**SAN ANTONIO WATER SYSTEM  
DOS RIOS WRC RE-RATING  
HEADWORKS IMPROVEMENTS AND  
PROCESS ENHANCEMENTS PHASE I  
SAWS Job No. 08-6502  
SAWS Solicitation No. B-10-057-DD**

**ADDENDUM No. 1  
November 24, 2010**

Texas Registration Number F-3043	DATE 11-23-10	SAN ANTONIO WATER SYSTEM DOS RIOS WRC RE-RATING HEADWORKS IMPROVEMENTS AND PROCESS ENHANCEMENTS PHASE I		ADDENDUM No 1	EXHIBIT No CZ-2-A
		REF SHEET No	LOCATION		
		CZ-2

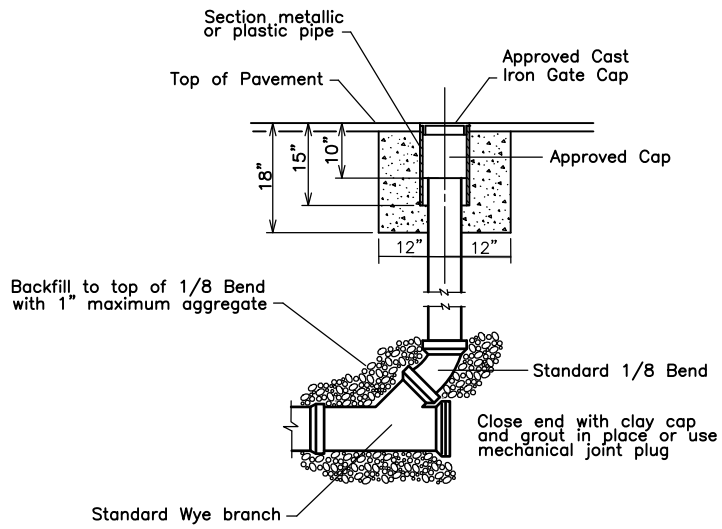
a) Revise sheet as shown in Exhibit CZ2-A.

Texas Registration Number F-3043	DATE <u>11-23-10</u>	SAN ANTONIO WATER SYSTEM DOS RIOS WRC RE-RATING HEADWORKS IMPROVEMENTS AND PROCESS ENHANCEMENTS PHASE I		ADDENDUM No 1	EXHIBIT No CZ-3-A
		REF SHEET No	LOCATION		
		CZ-3

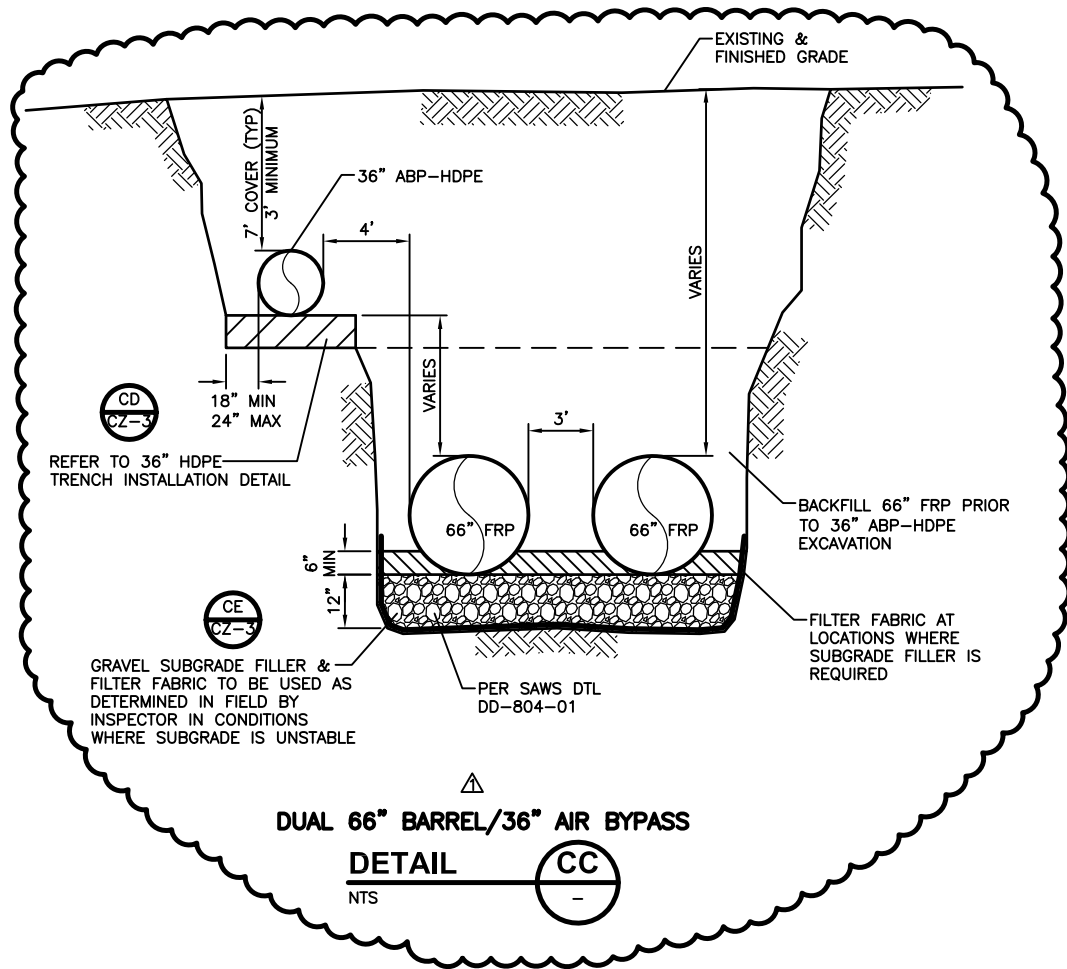
a) Revise sheet as shown in Exhibit CZ3-A.

Texas Registration Number F-3043	DATE 11-23-10	SAN ANTONIO WATER SYSTEM DOS RIOS WRC RE-RATING HEADWORKS IMPROVEMENTS AND PROCESS ENHANCEMENTS PHASE I		ADDENDUM No 1	EXHIBIT No CZ-4-A
		REF SHEET No	LOCATION		
		CZ-4

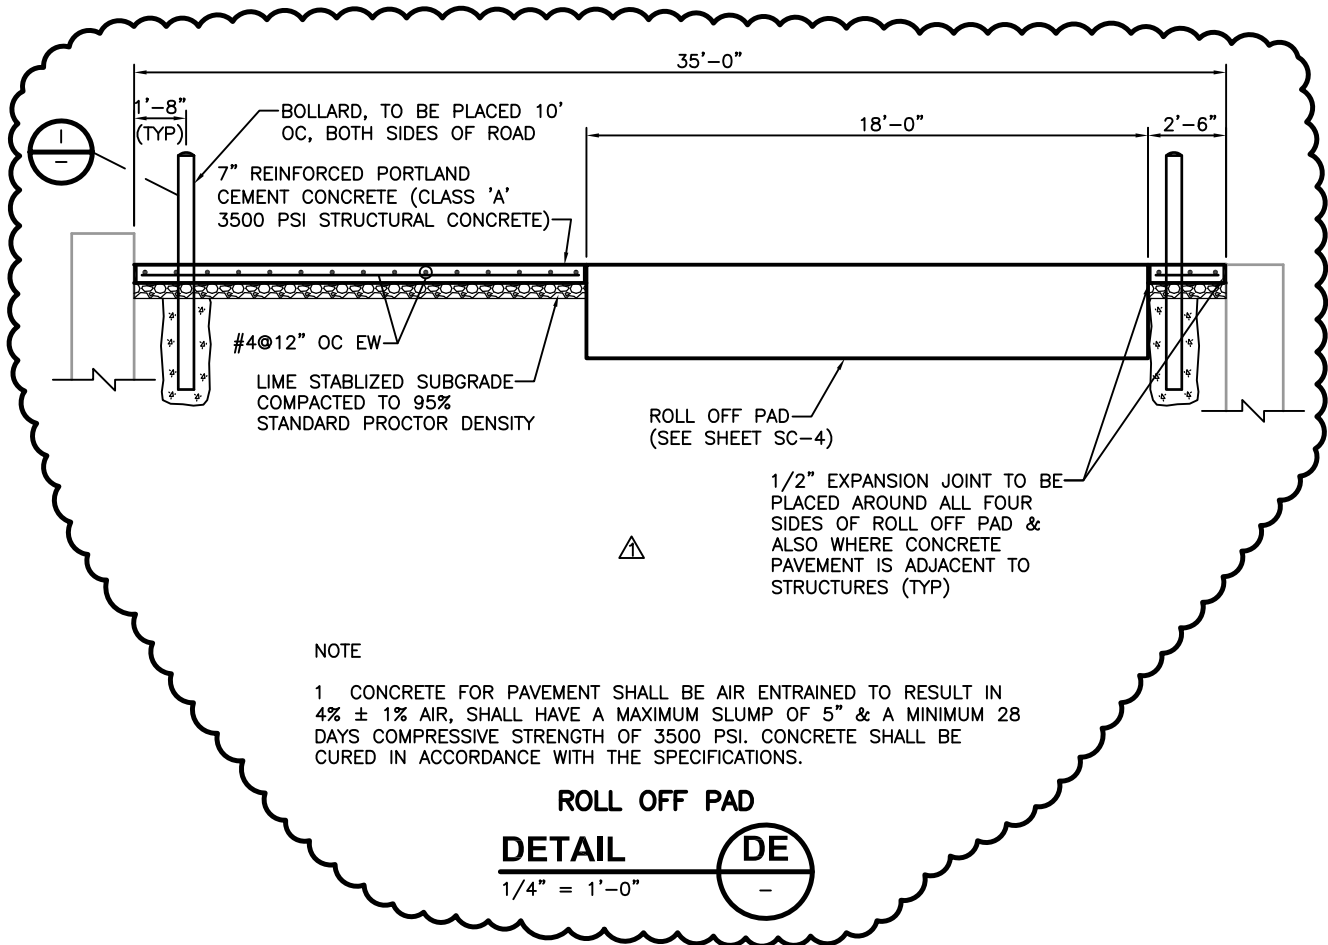
a) Revise sheet as shown in Exhibit CZ4-A.

SAN ANTONIO WATER SYSTEM  
DOS RIOS WRC RE-RATING HEADWORKS  
IMPROVEMENTS AND PROCESS ENHANCEMENTS PHASE I

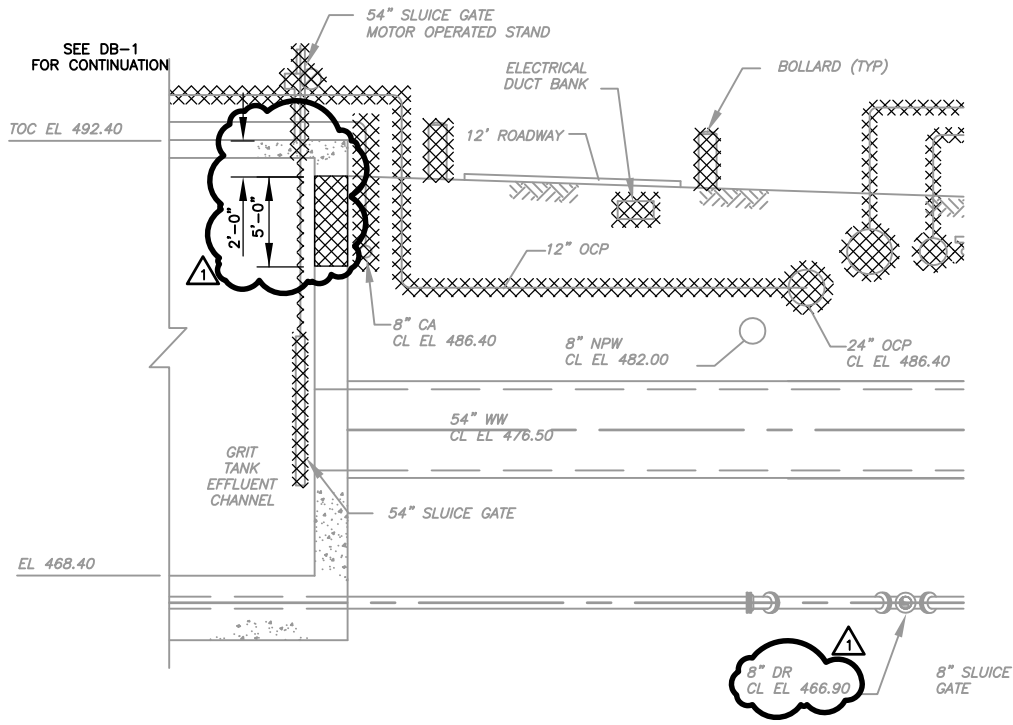
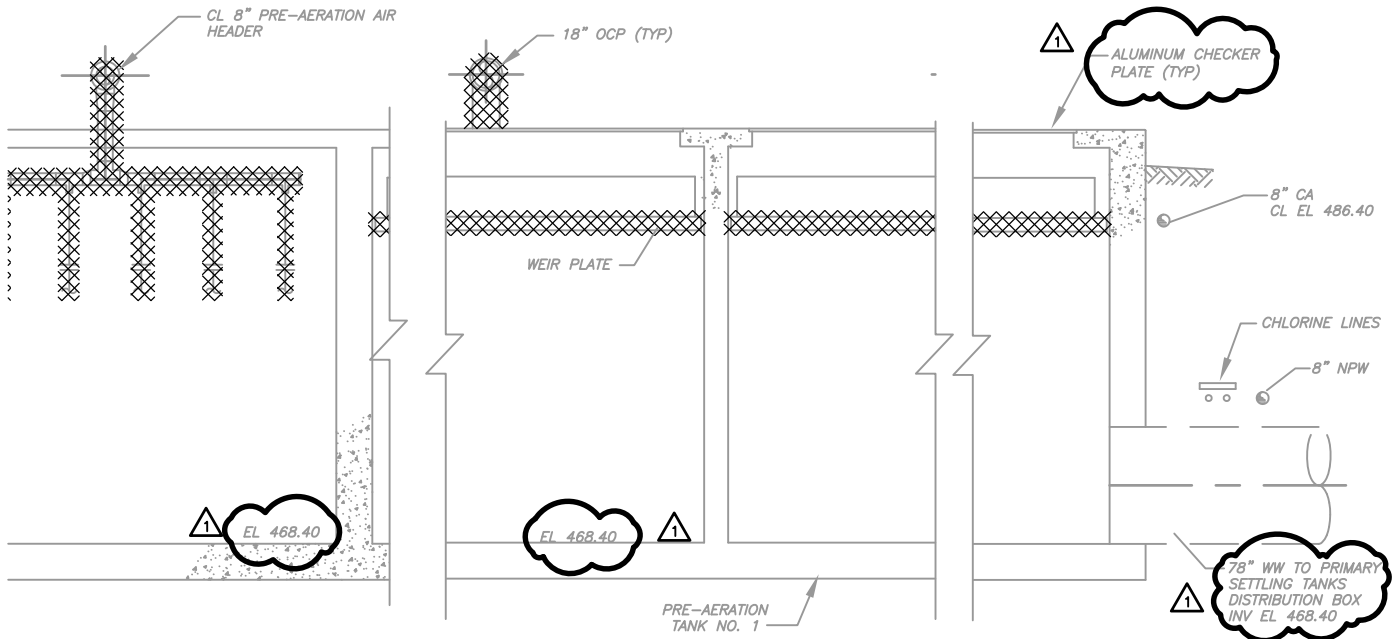
a) Revise sheet as shown in Exhibit DC2-A.

PROJECT No	65767
FILE NAME:	SB-4
SHEET No	SB-4
OF	—

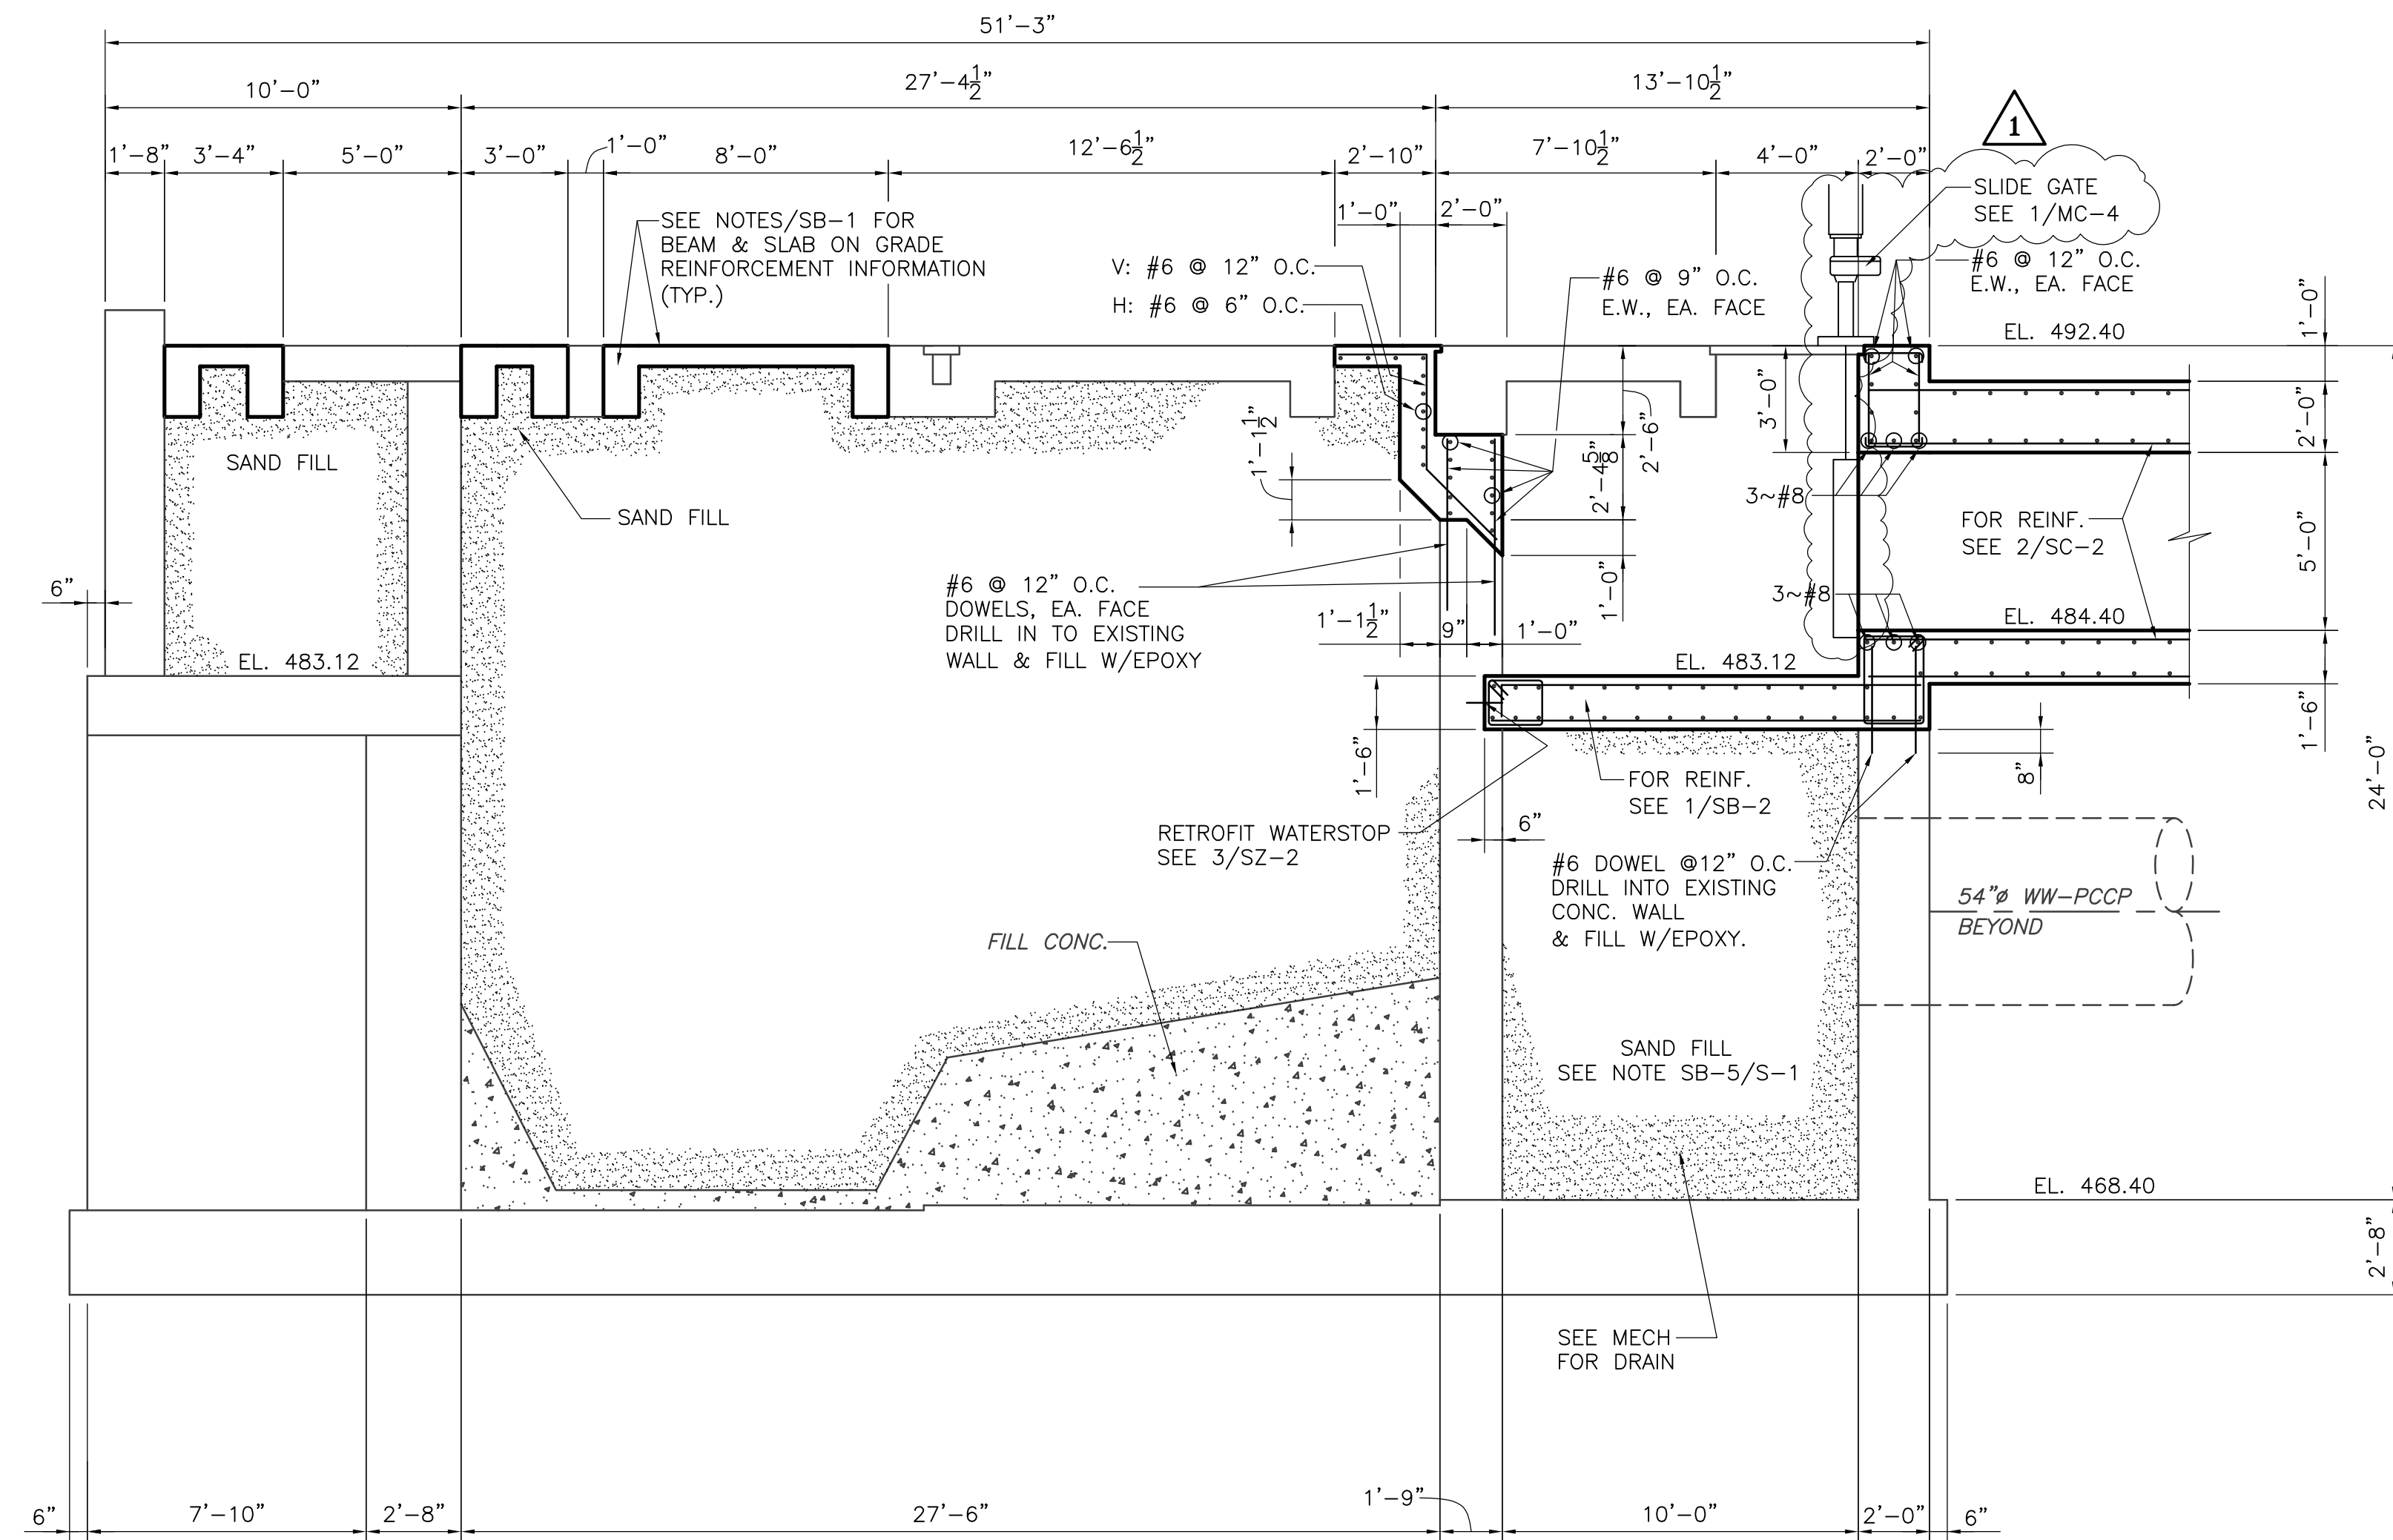
- Q2. At the Influent Screening Structure, Section 4 on Sheet SB-3, the epoxy coating system is shown and called out to be applied to "All Walls and Slabs". Does that note apply to all walls and slabs throughout the entire structure? The epoxy is only called out at this section; however it appears to be drawn at some sections, yet not at others. If we are to coat all walls and slabs throughout the structure, does this include all existing concrete?

- A2. This will be made more clear (on the drawings) with the next addendum. Protective coating is being considered for all new interior surfaces and all existing which are becoming interior surfaces. The existing surfaces that already have a liner will need to be evaluated at construction time.

SAN ANTONIO WATER SYSTEM  
DOS RIOS WRC RE-RATING HEADWORKS  
IMPROVEMENTS AND PROCESS ENHANCEMENTS PHASE I

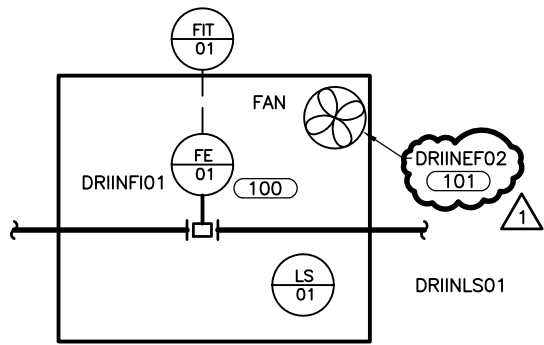
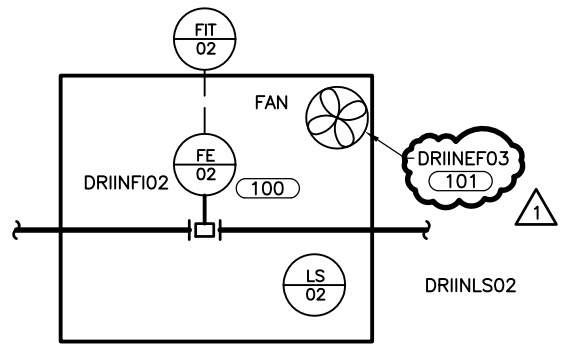
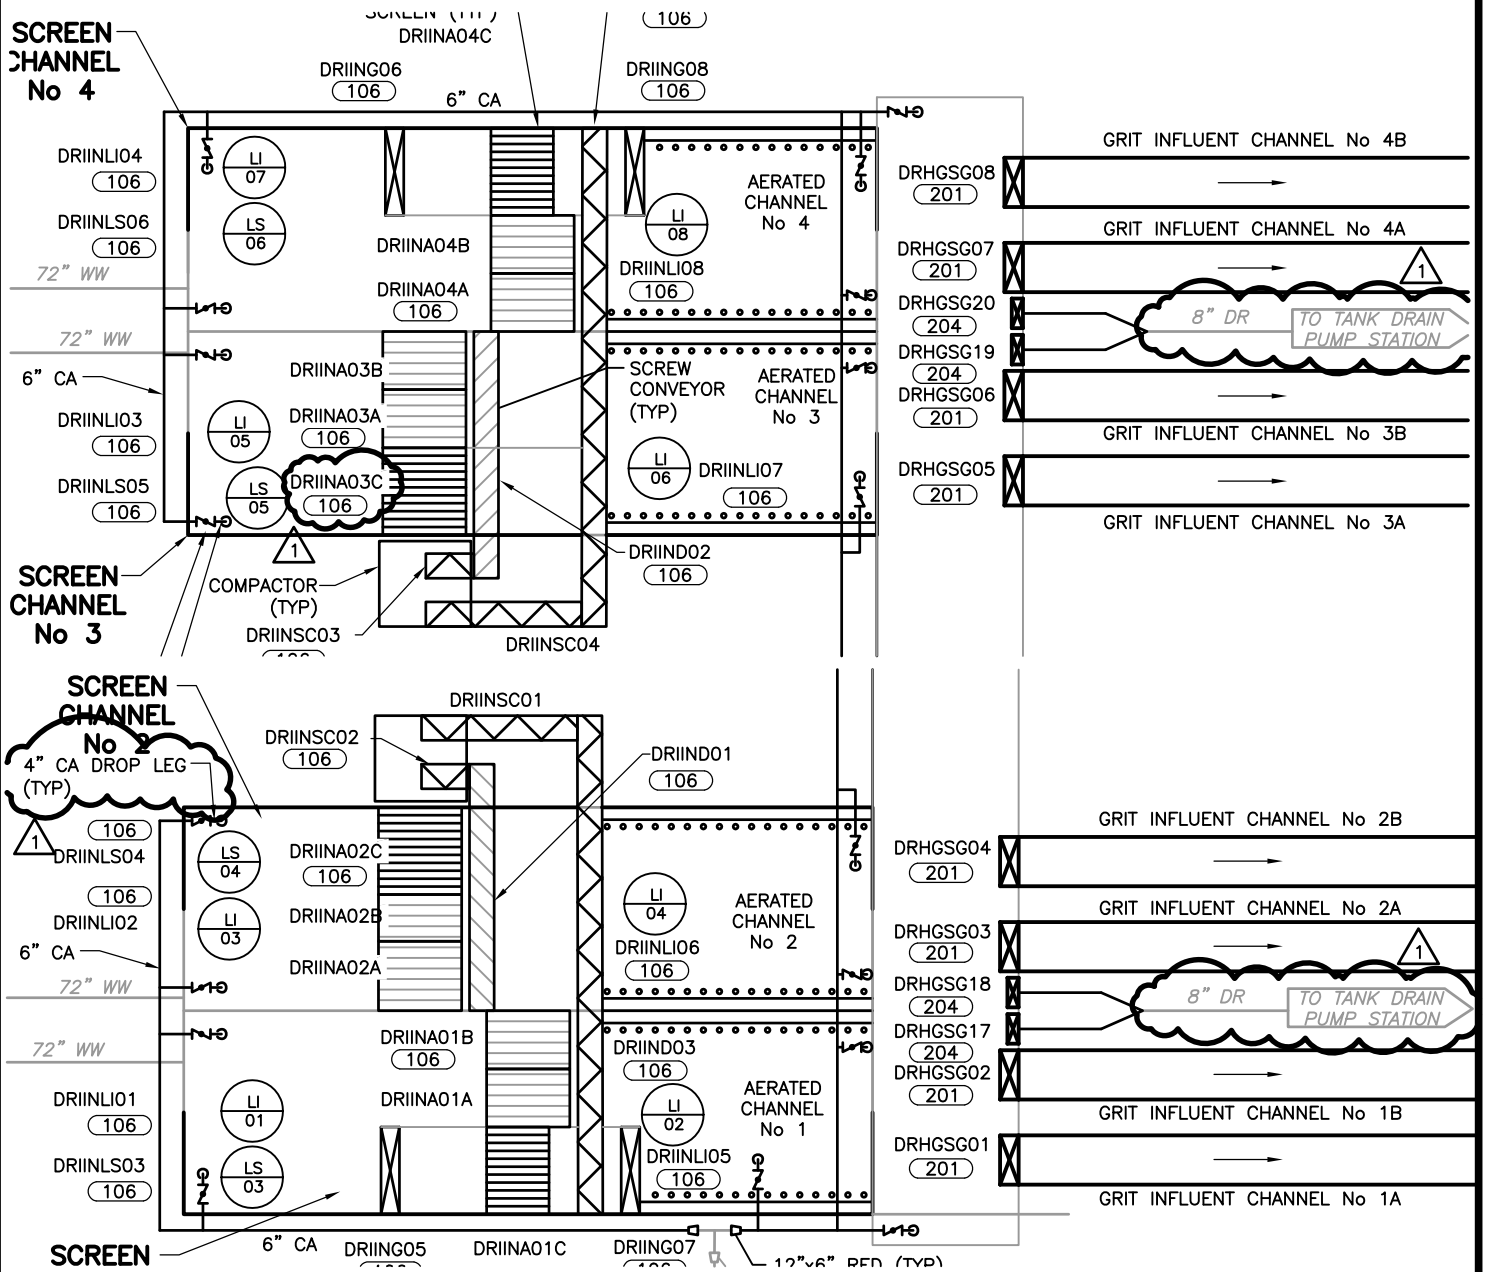
- a) Revise sheet as shown in Exhibit P1-A.
